**RE: McDonald's - 7943 Ladera DR NW**  
**30-day Temporary C.O. - Accepted**  
**Engineer's Certification Date: 12/18/23**  
**Engineer's Stamp Date: 09/22/22**  
**Hydrology File: H09D020**

## DRAINAGE AND TRANSPORTATION INFORMATION SHEET (REV 6/2018)

DISC# 2020.1044 - McDONALD'S USA, LLC 30-0263 - NEW BUILD 7343 LADERA DRIVE NW, ALBUQUERQUE, NM DRAWINGS C7.0 GRADING PLAN DWG

**C7.0 GRADING PLAN**

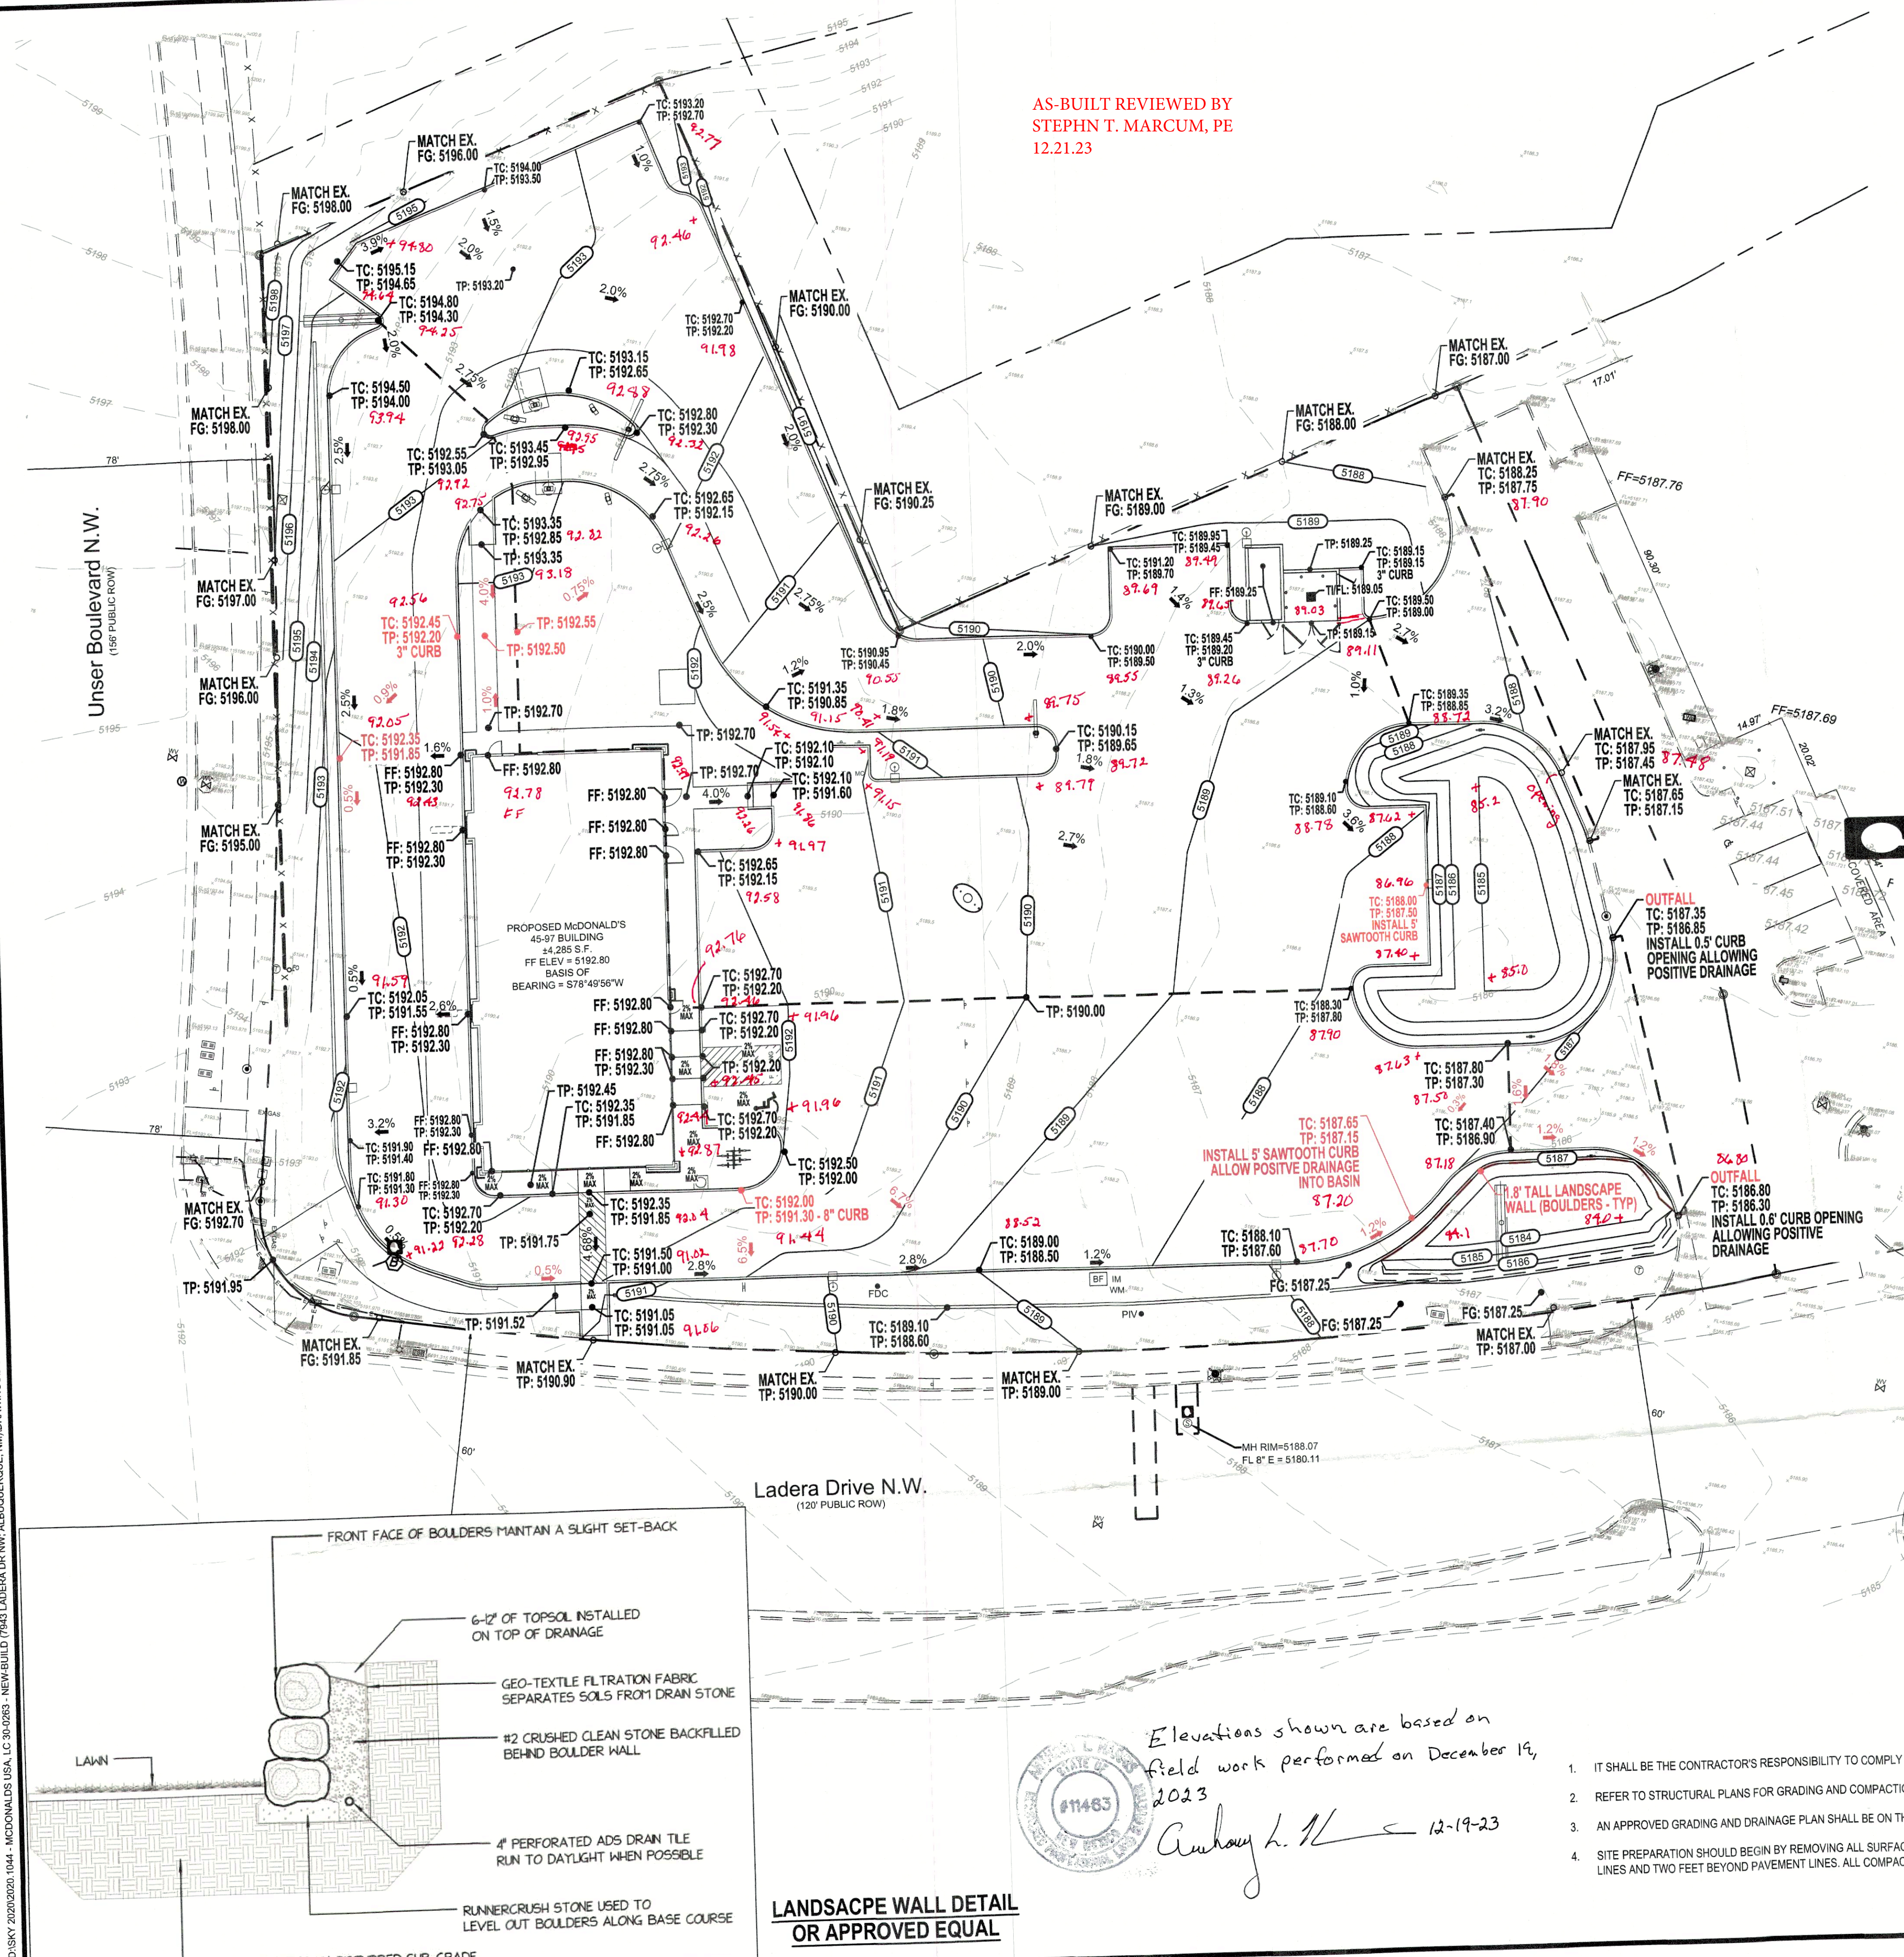
1. Please Resubmit to [PLNDRS@cabq.gov](mailto:PLNDRS@cabq.gov) when ready with an updated City of Albuquerque engineer's certification on the as-built Grading & Drainage Plan.
